CONTRACT NO. <i>82-C-4331</i>	TRANSMITTAL NO. <i>24</i>	DATE <i>3/5/84</i>
PROJECT TITLE AND LOCATION <i>Replace 3 water wells MCB, Camp Lejeune, NC.</i>

Subj: CONTRACT N62470-82-C-4551, REPLACE 3 WATER WELLS, MCB, CAMP LEJEUNE, NC

CONTRACT NO. N62470-82-C-4551	TRANSMITTAL NO. 15	DATE 8-26-83
PROJECT TITLE AND LOCATION Replacing Three (3) Water Wells, MCB, Camp Lejeune, N. C.		
WELL #M-168

Subject: Replace Water Wells
 Buildings 601, M-168, & BB-43
 Construction Contract No. N62470-82-B-4551
 Enwright Job No. 82005-00-2-01

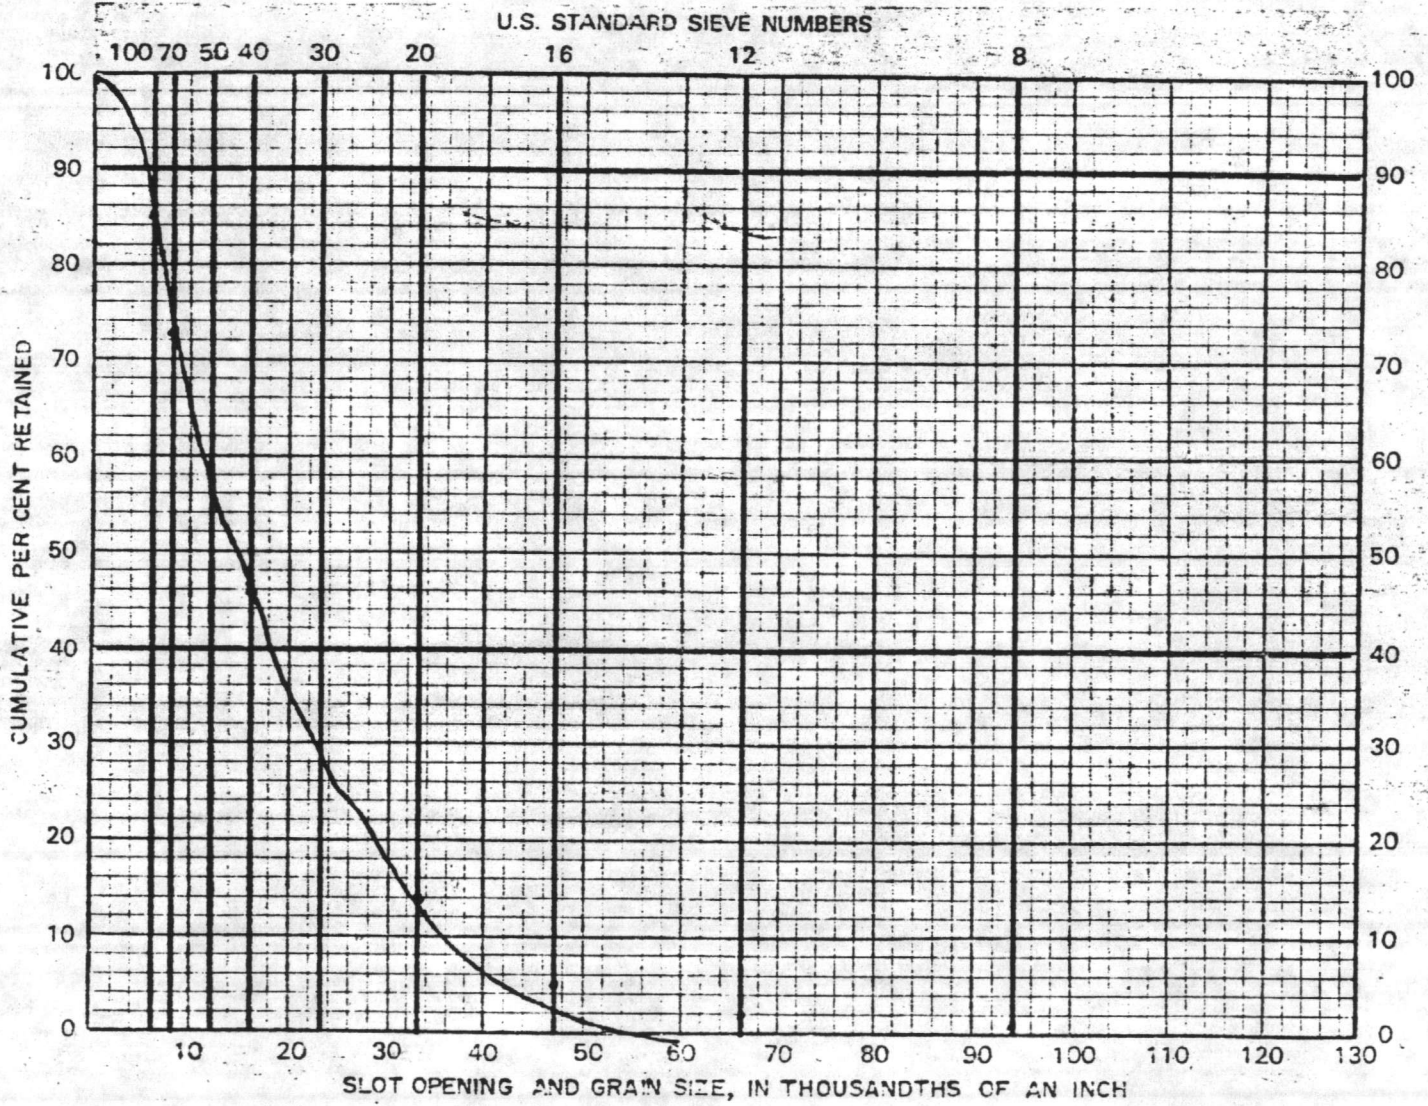
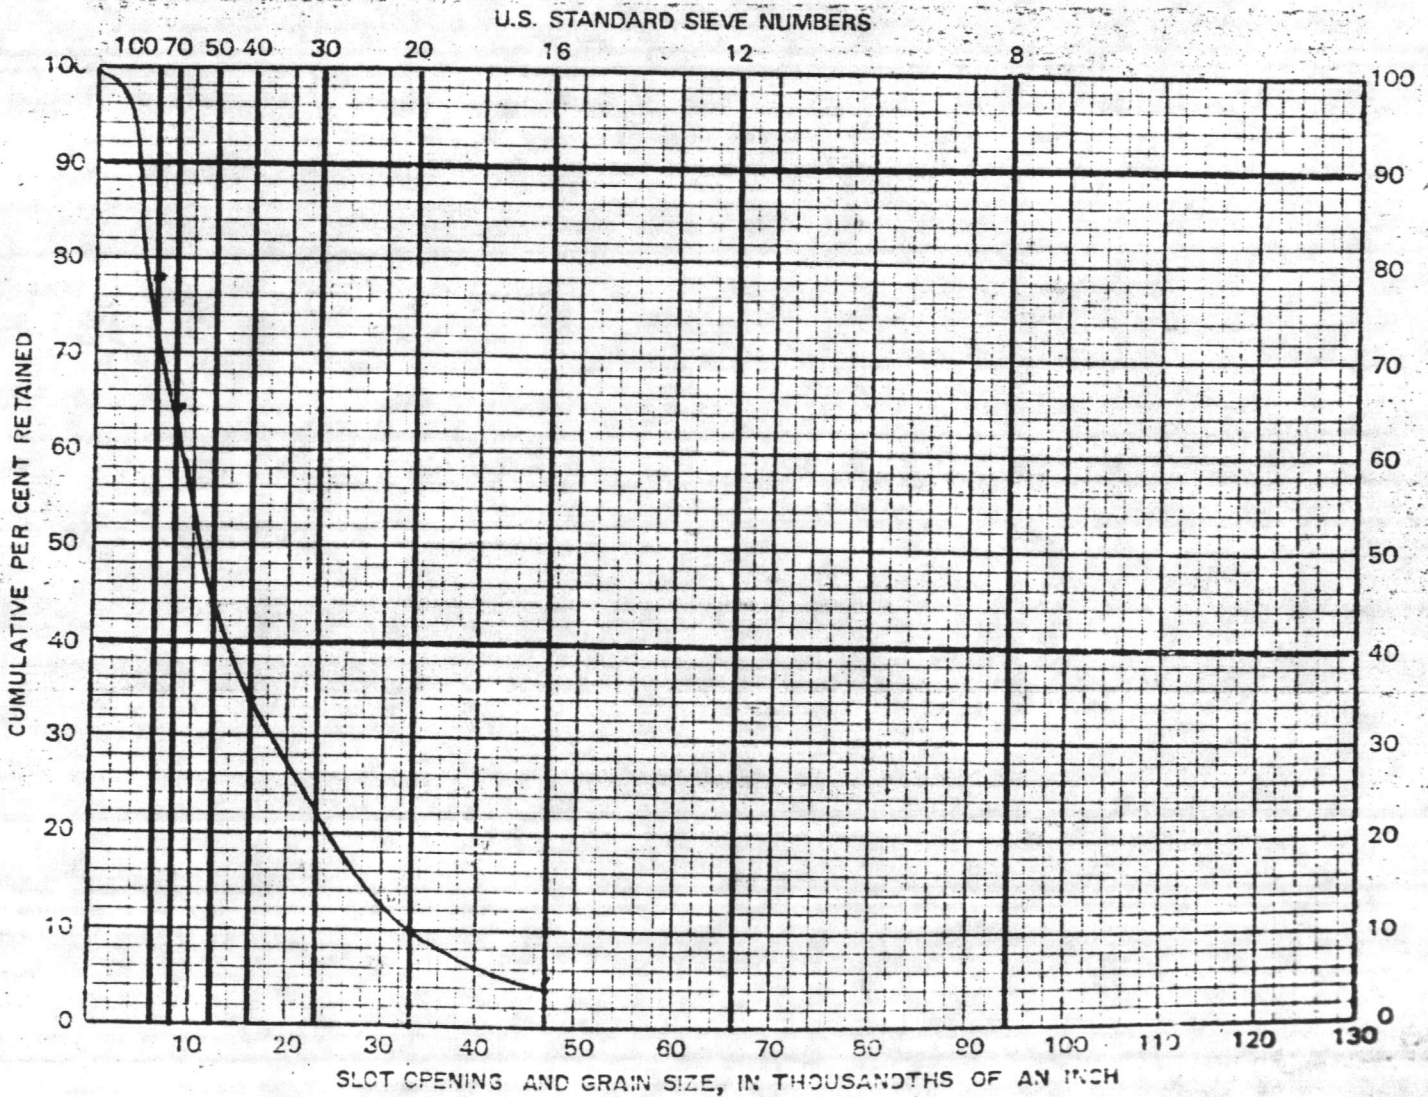
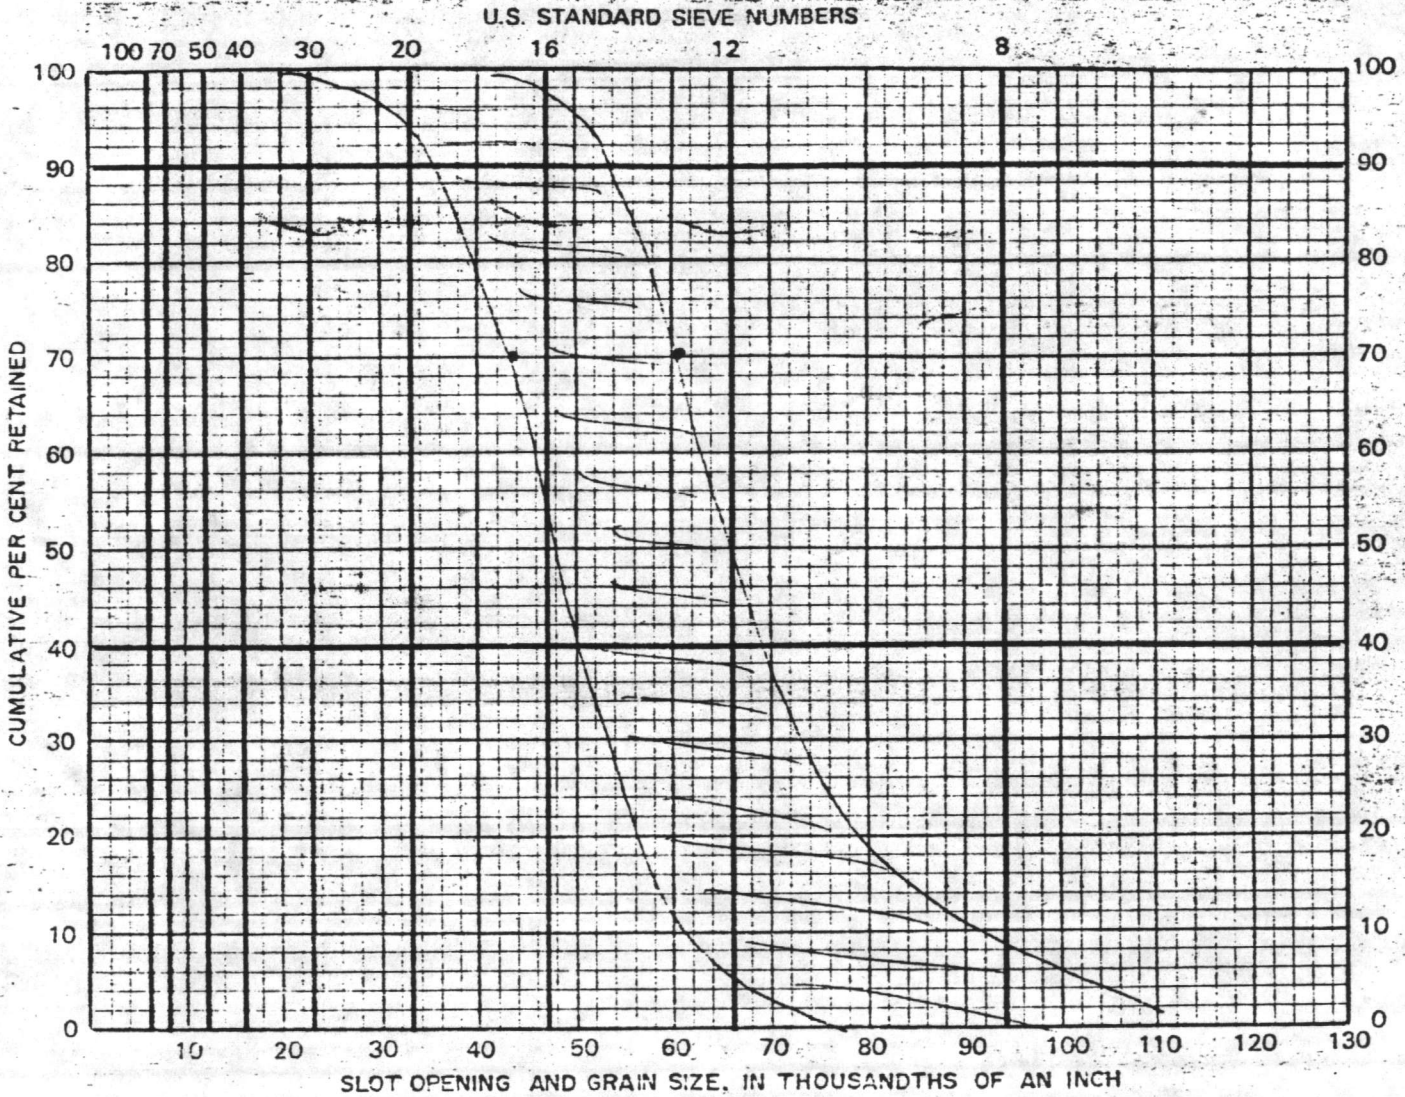
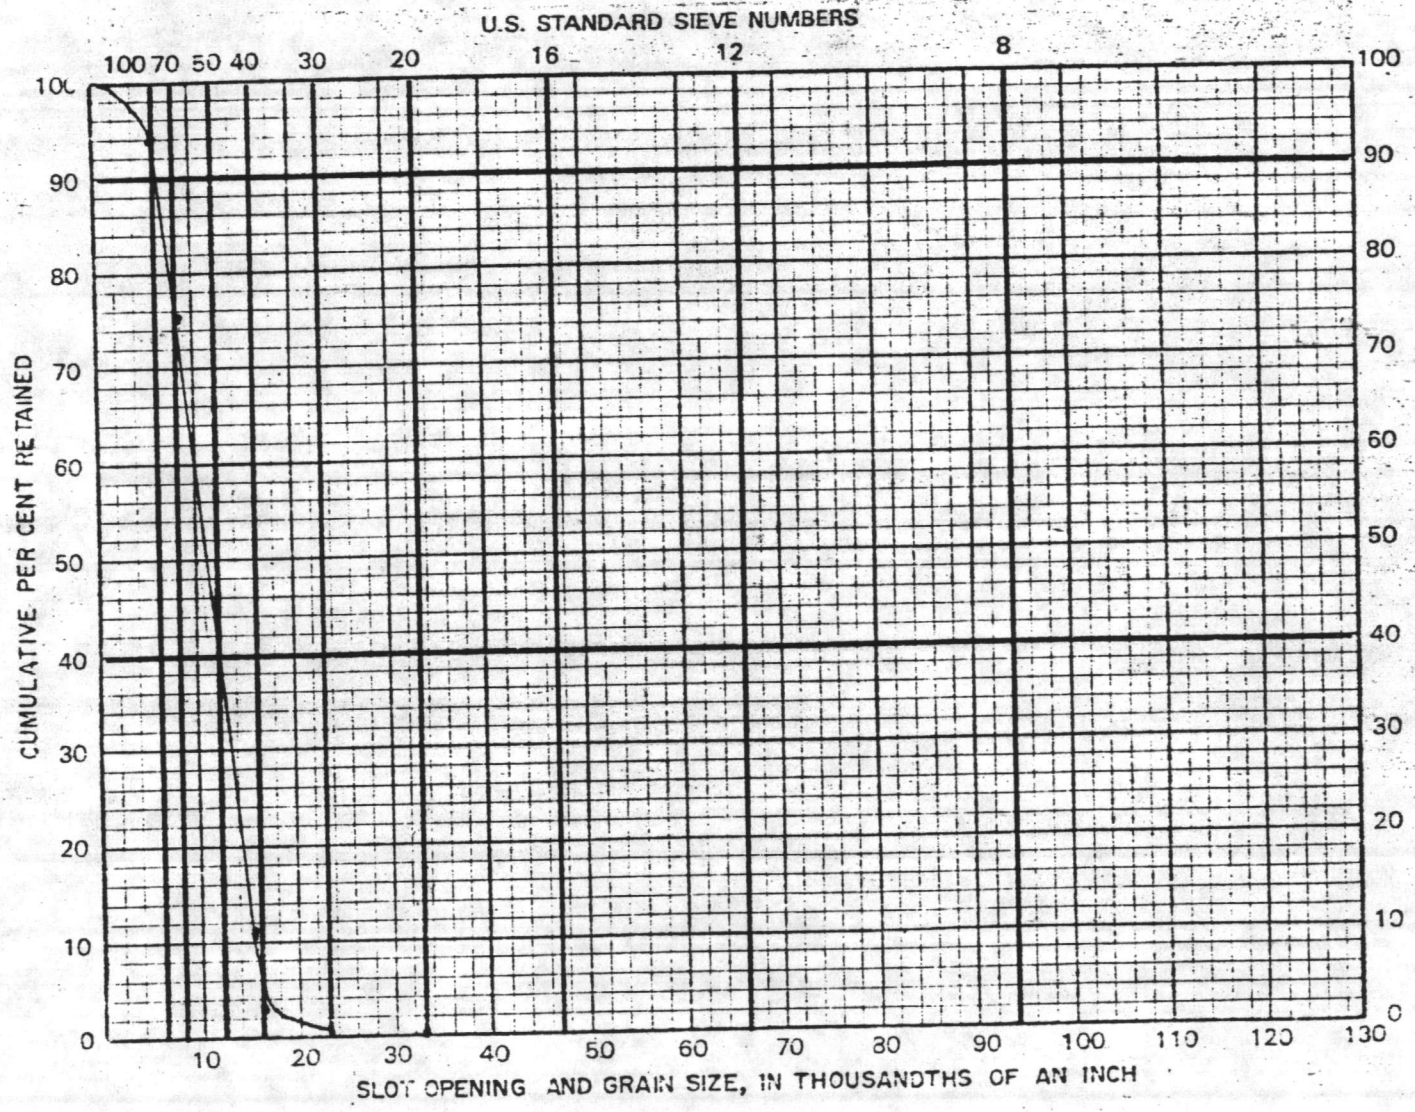
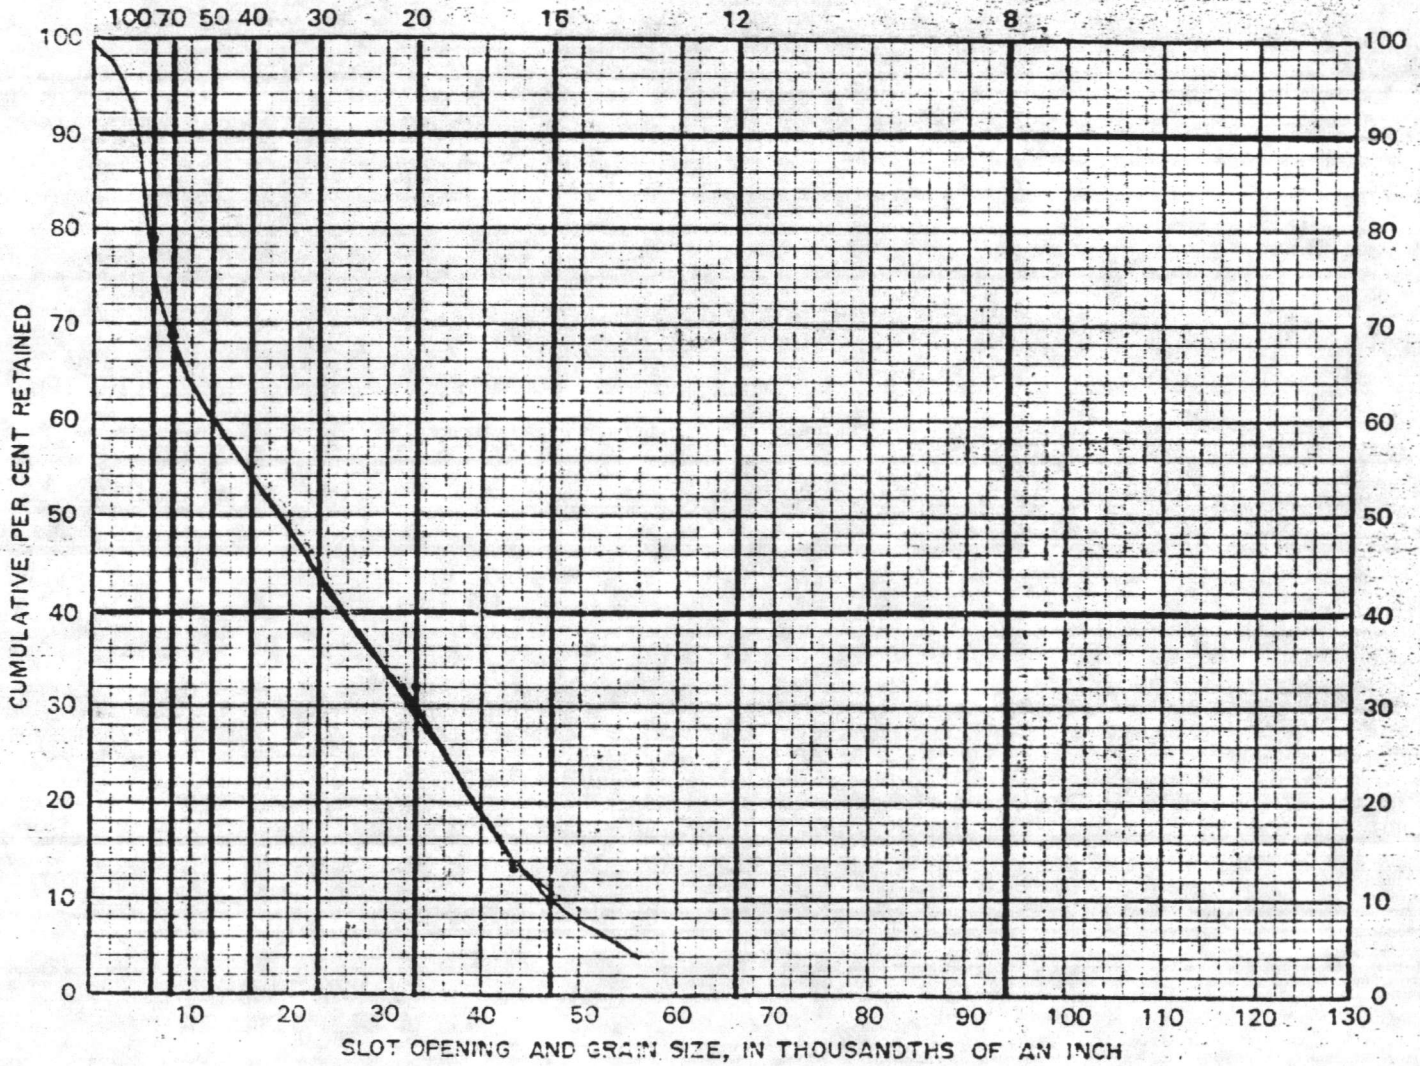
- . The .30 inch slot for the stainless steel screens appears to be too large.
- . All wells shall be packed with gravel having a uniformity coefficient of not more than 2.5. The contractor recommends course sand.
- . Electric log for well number ~~M~~-601 was not submitted.
- . Well numbers M-168 and BB-43 do not meet specified yield.

We are requesting a resubmittal of the attached which should address the items mentioned above. Please advise as to acceptance or rejection of estimated yield for wells M-168 and BB-43.

We are still recommending a .30 slot stainless steel screen and a course sand gravel pack. Sample attached. We base our recommendation on the attached sieve analysis from Johnson Company and our past experience in the development of water wells in this area.

We feel this method will offer the most efficient and productive well. As for the quantity of available water we base our recommendation on the attached gamma and electric logs and pumping test.
